Access Compliance Report

Public Rights-of-Way

(Curb Ramps)

Intersection ID: 48563	Main Street: MASON_MILL_PL	Cross Street: HAINES_MILL_RD	Location: SW
ADA ID: 6DEAAB6DC0B9	Ramp Type: BlendTrans1	Initial Pass/Fail: Fail	Overall Compliance: No
Severity Score: 33.75			
Codes/Mitigation Info/Possible Solution		Field Measurements/Component Compliance

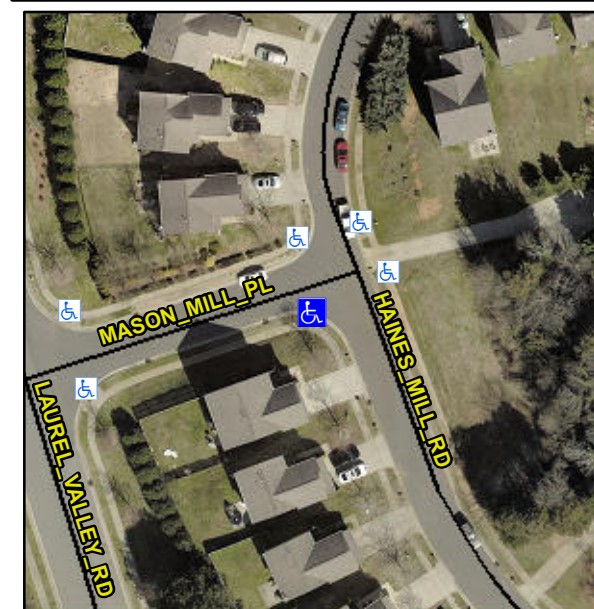
Not Found, R304.5.1, R304.5.3

Compliance	Description	Data	Compliance	Description	Data
N/A	Ramp Length (in)	48.0	Yes	BlendTrans Slope (%)	2.0
No	Ramp Width (in)	47.0	No	BlendTrans XSlope (%)	7.1
N/A	Flare Type LT	N/A	N/A	Flare Type RT	N/A
N/A	Flare Slope LT (%)	N/A	N/A	Flare Slope RT (%)	N/A
N/A	Flare Traversable LT?	N/A	N/A	Flare Traversable RT?	N/A
N/A	Landing Length (in)	N/A	N/A	DWS Provided?	N/A
N/A	Landing Width (in)	N/A	N/A	DWS Contrast?	N/A
N/A	Landing Slope (%)	N/A	N/A	DWS Length (in)	N/A
N/A	Landing X Slope (%)	N/A	N/A	DWS Full Width?	N/A
N/A	Landing Curb? (Y/N)	N/A	N/A	DWS Offset (in)	N/A
N/A	Shared Landing?	N/A			
N/A	Gutter Ponding?	N/A	N/A	Gutter Slope (%)	N/A
N/A	Gutter Lip Ht (in)	N/A	N/A	Gutter X Slope (%)	N/A
N/A	Painted X Walk1?	No	N/A	Painted X Walk2?	No
	X Walk 1 Direction	To E		X Walk 2 Direction	To N
	X Walk 1 Width (in)	N/A		X Walk 2 Width (in)	N/A
	X Walk 1 Slope (%)	6.2		X Walk 2 Slope (%)	2.3
	X Walk 1 X Slope (%)	2.5		X Walk 2 X Slope (%)	5.7

N/A	Ramp inside XWalk1?	N/A	N/A	Ramp inside XWalk2?	N/A
	Road Slope (%)	4.5		Clear Space?	N/A
	Road X Slope (%)	5.2	N/A	Clear Space to XWalk (in)	N/A
N/A	Any Obstructions?	N/A	N/A	Storm Grate/Utility Hazard?	N/A
	Obstruction Type			Storm Grate/Utility Type	
		N/A			N/A
			Yes	Surface Condition? (G/P)	Good
			No	Curb Slope (%)	14.4

Remove & Replace Curb Ramp With Two New Directional Ramps or Equivalent.
